Title:	Proposed Great Wolf Lodge, Chesterton, Bicester	Date Approved:	August 2022
Discipline:	Civils	Author:	Paul Davis
Note Ref:	2180501-EWP-XX-ZZ-TN-C-0006

This technical note has been prepared in response to the Lead Local Flood Authority (LLFA) comments on Condition 16 of application number 22/01815/DISC dated 19.07.22.

Catchment plan and updated below ground drainage drawings

elliottwood engineering a bettersociety

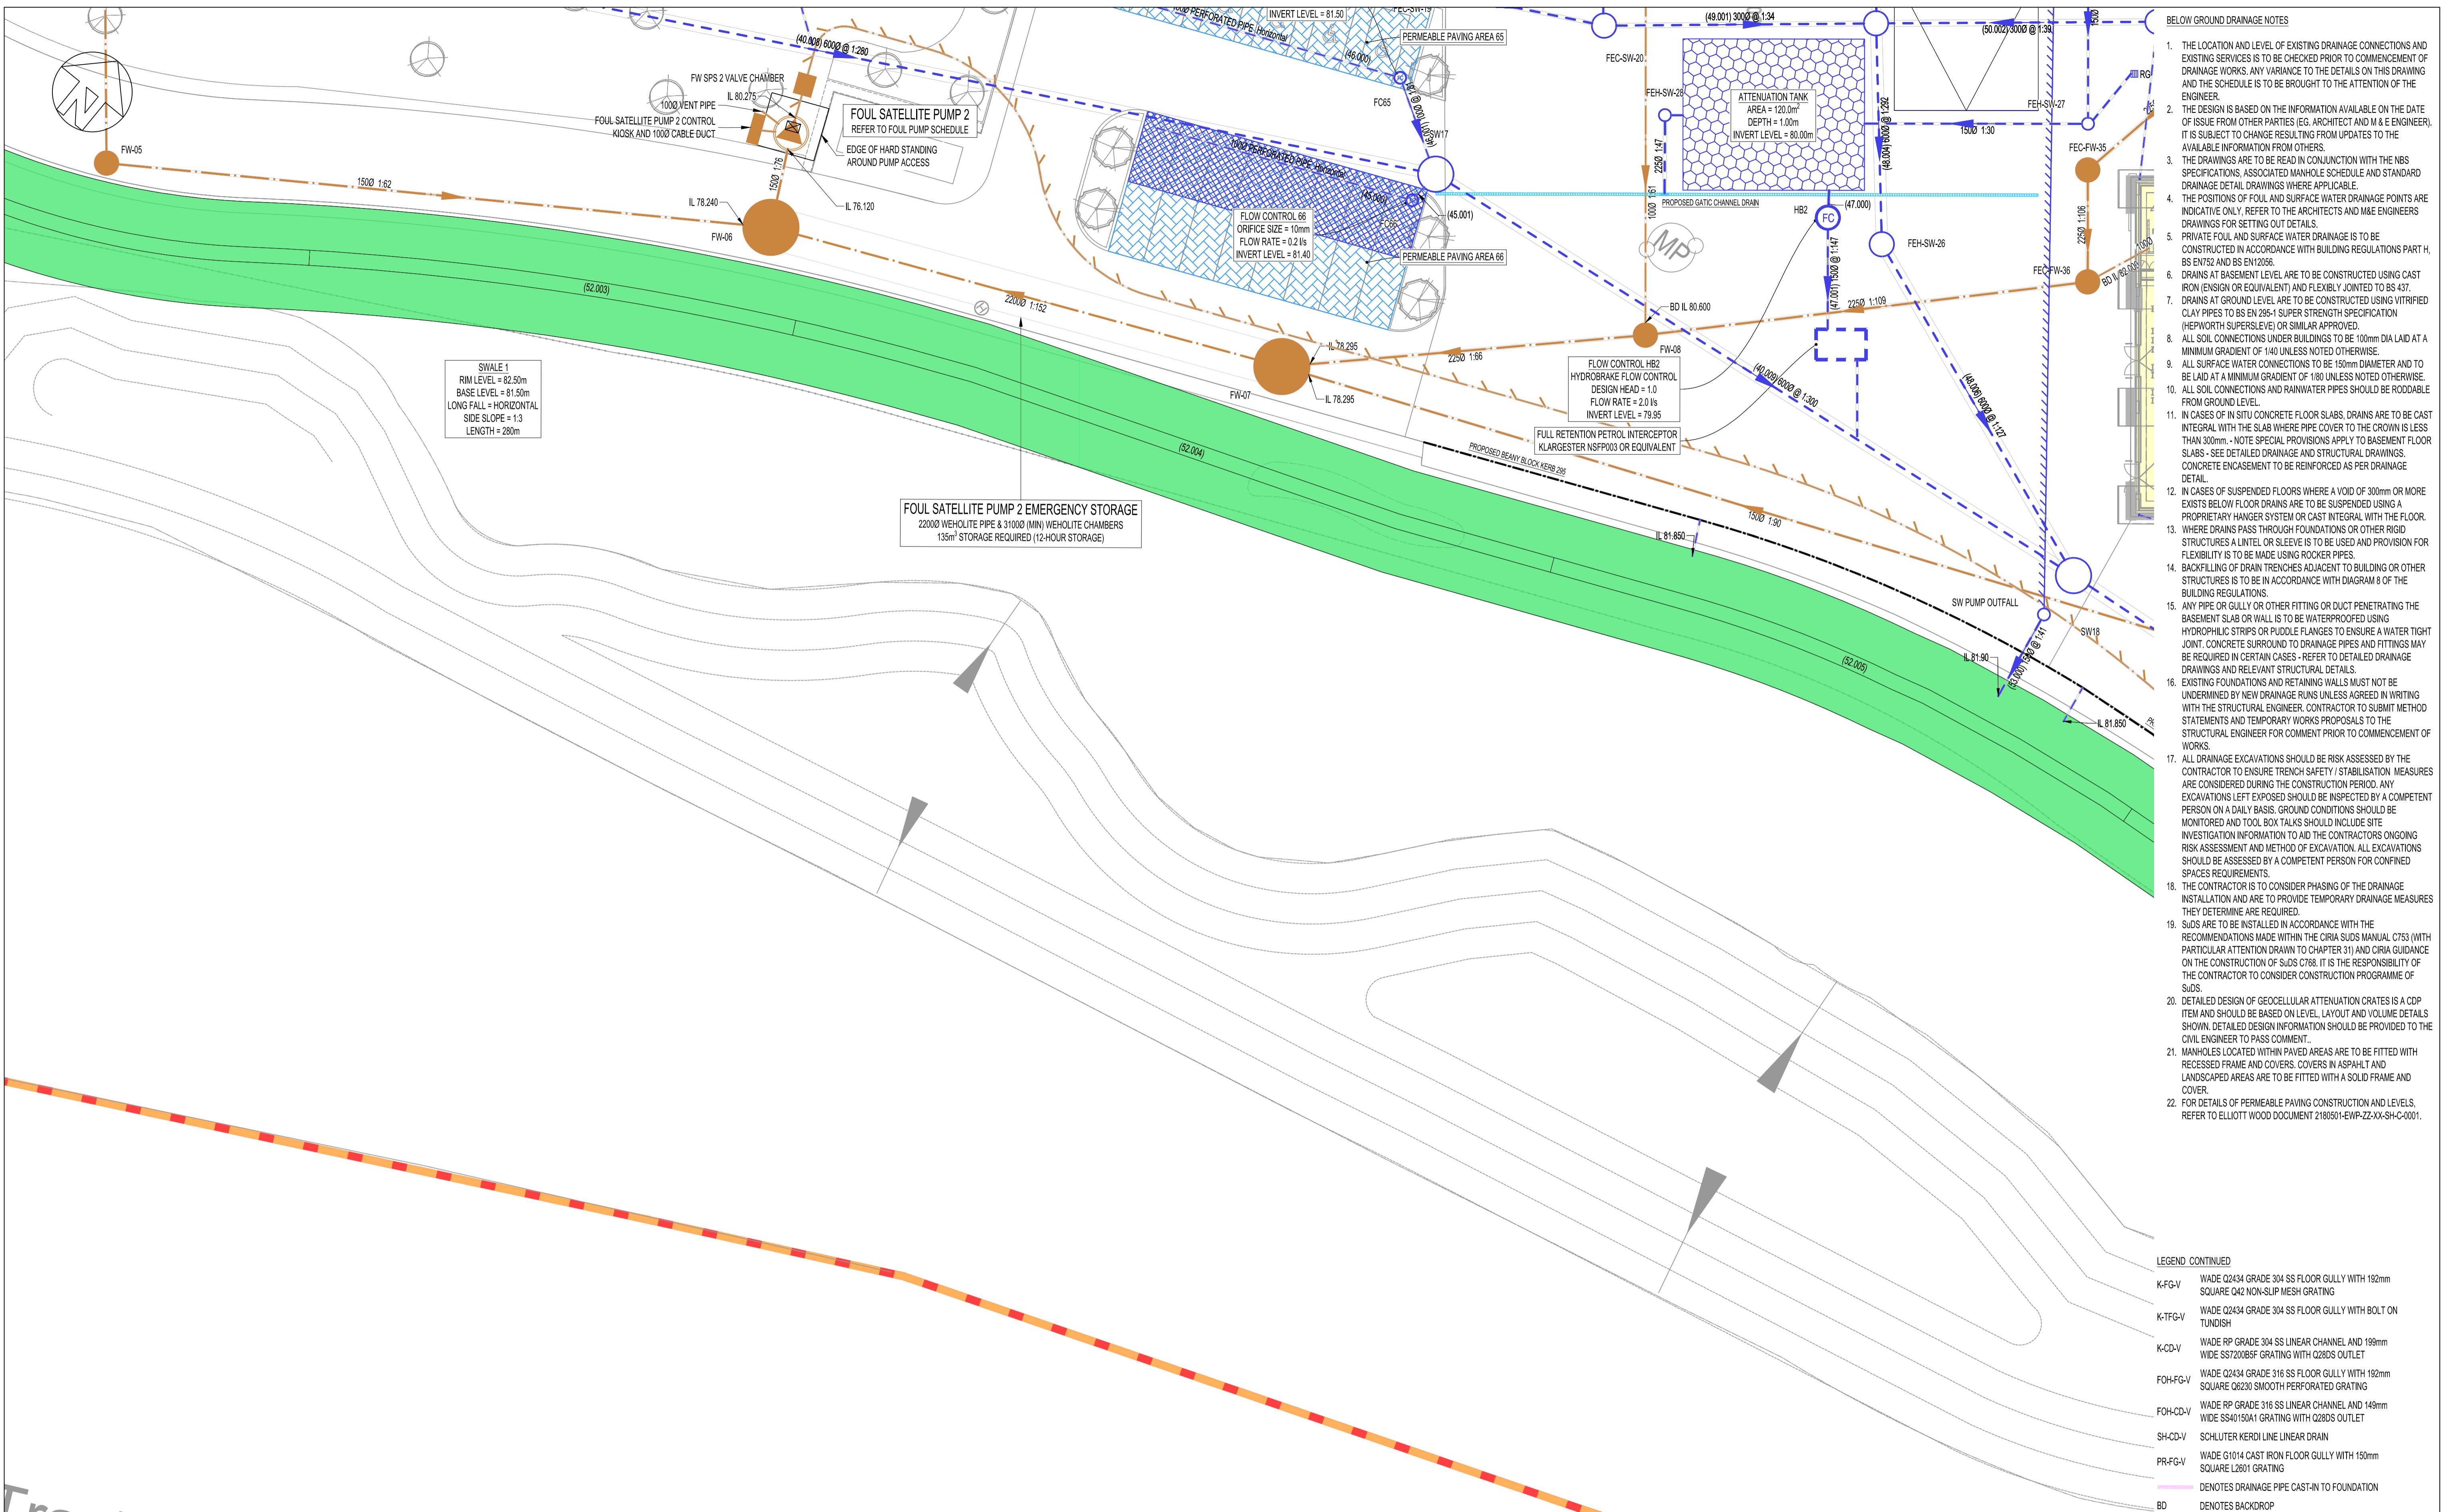
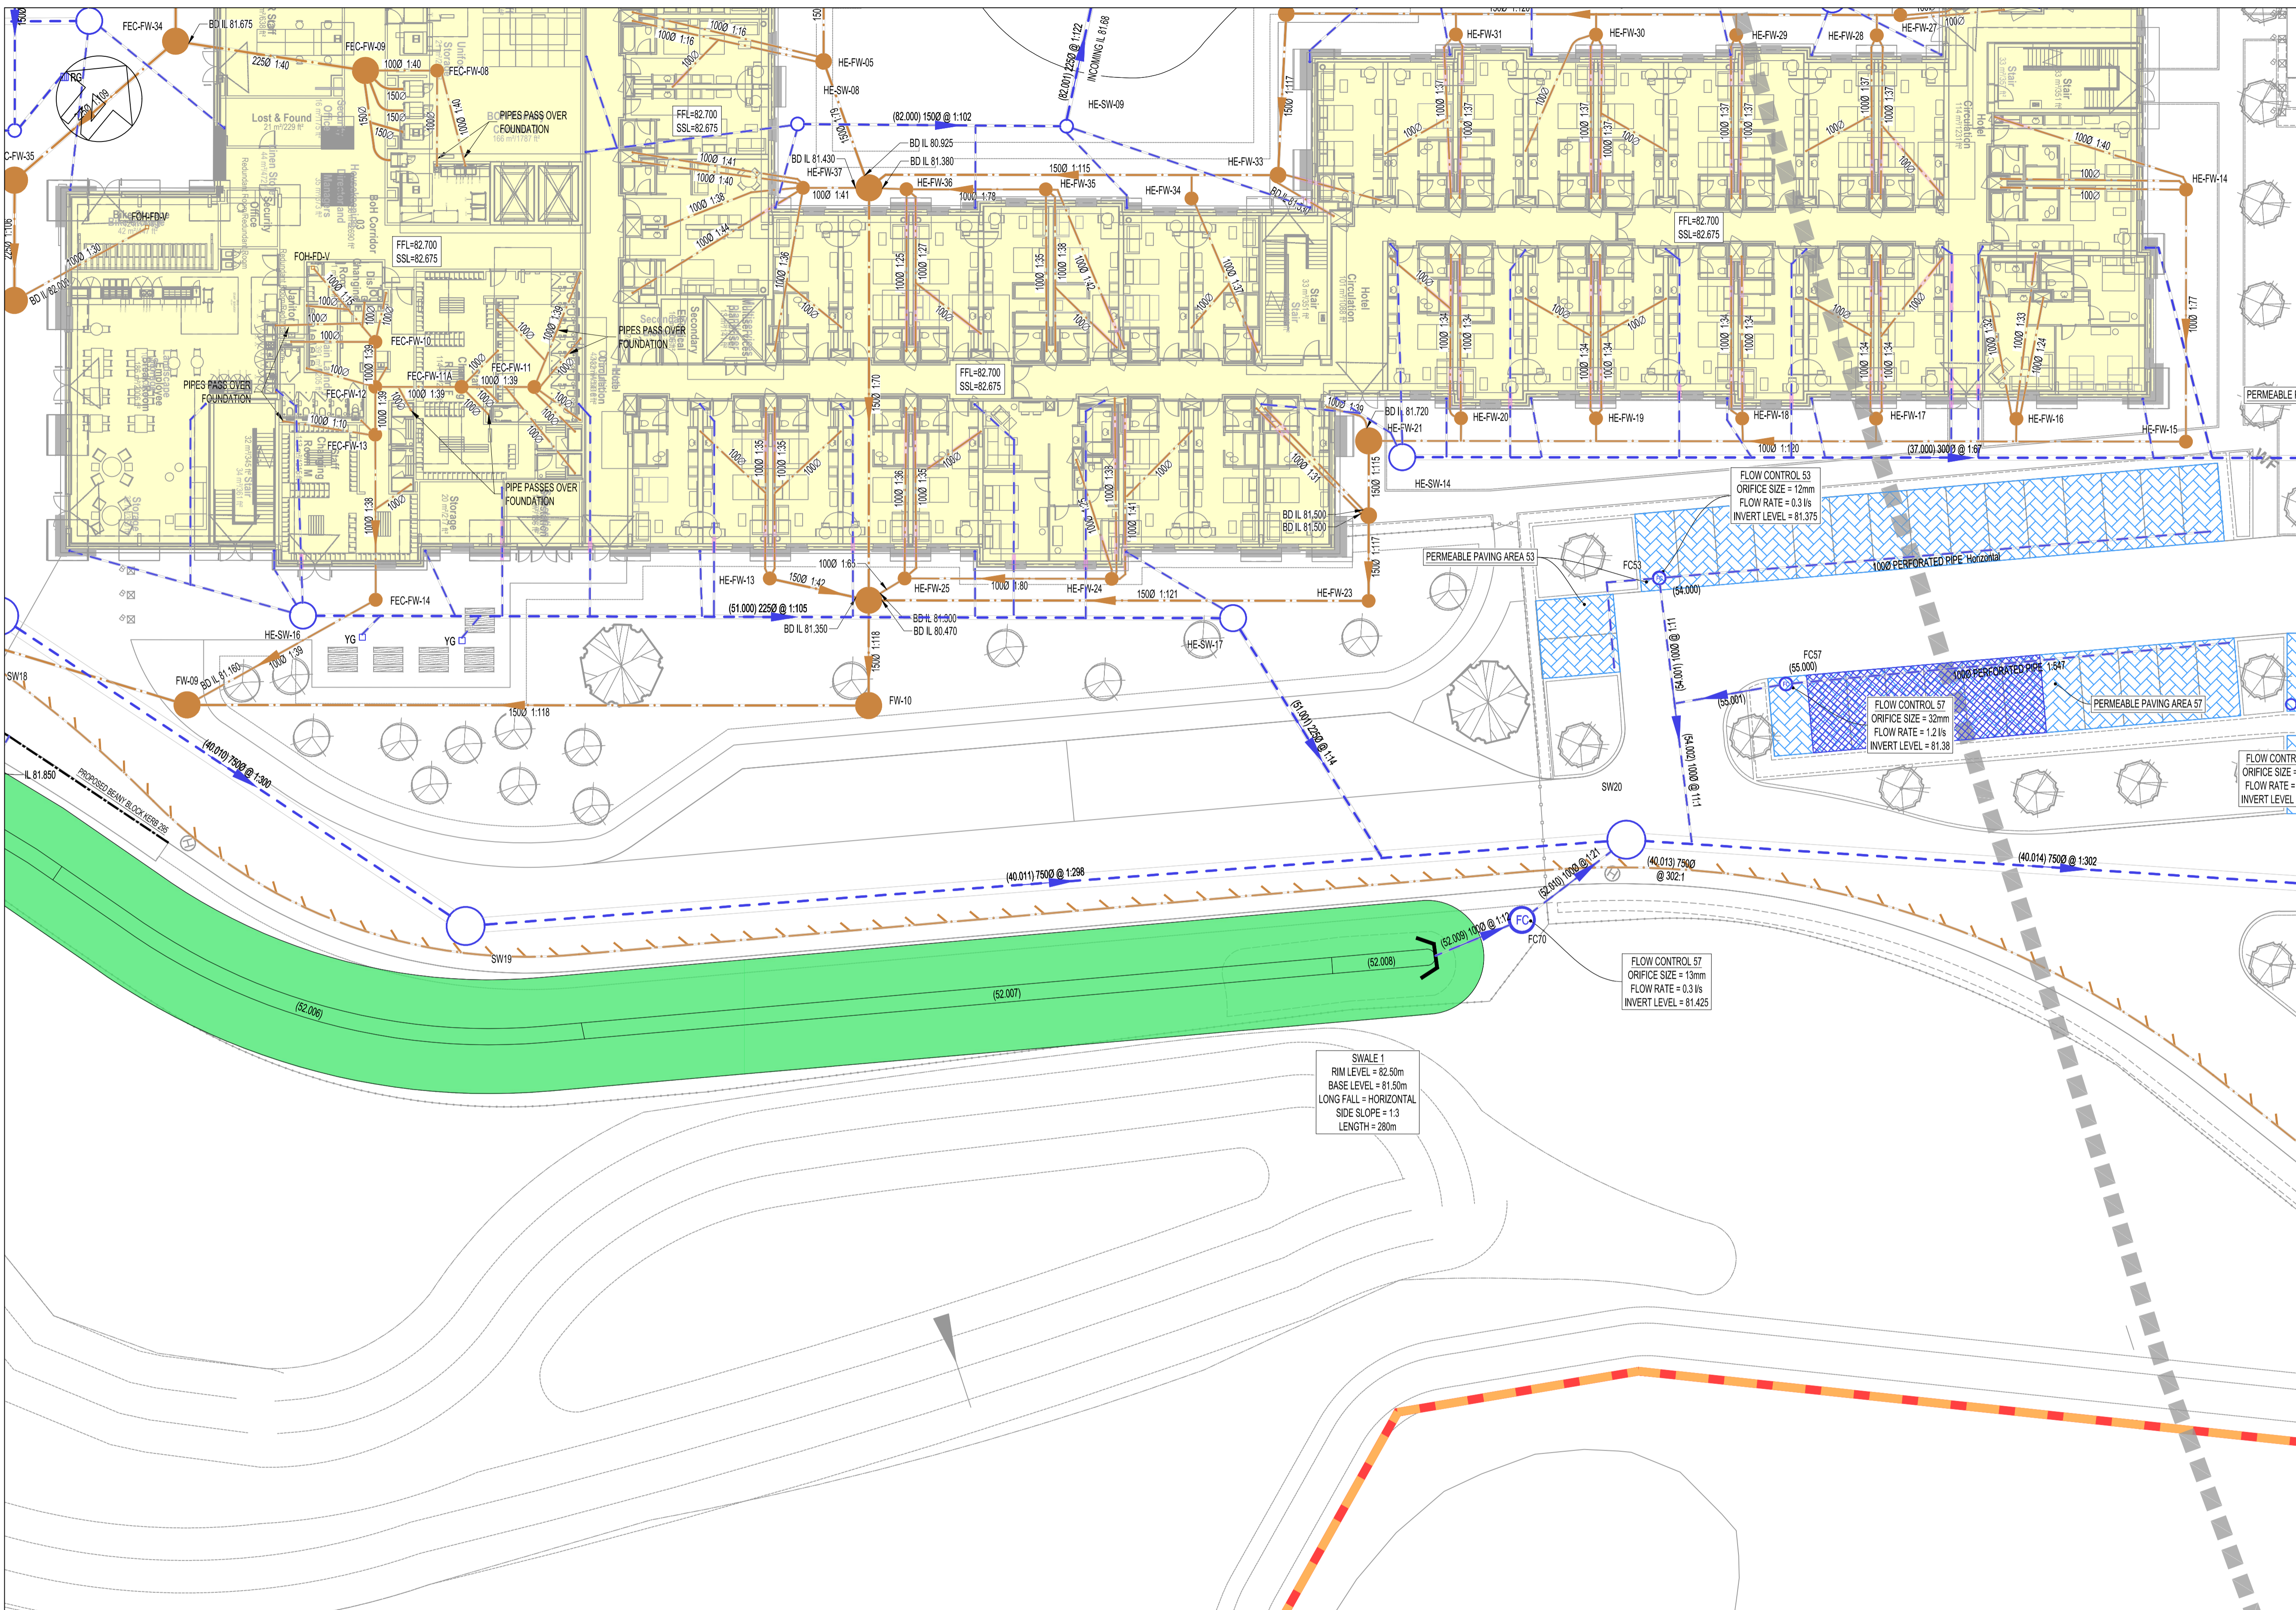
b) Provide surface water catchment plan, clearly showing the extent of the area and stating the area. Ensure all SuDS features are labelled on the drainage strategy drawing and read in line with the calculations.

A catchment plan has been prepared, in addition pipe numbers have been added to the below ground drainage drawings, these drawings are presented in **Appendix A** of this report.
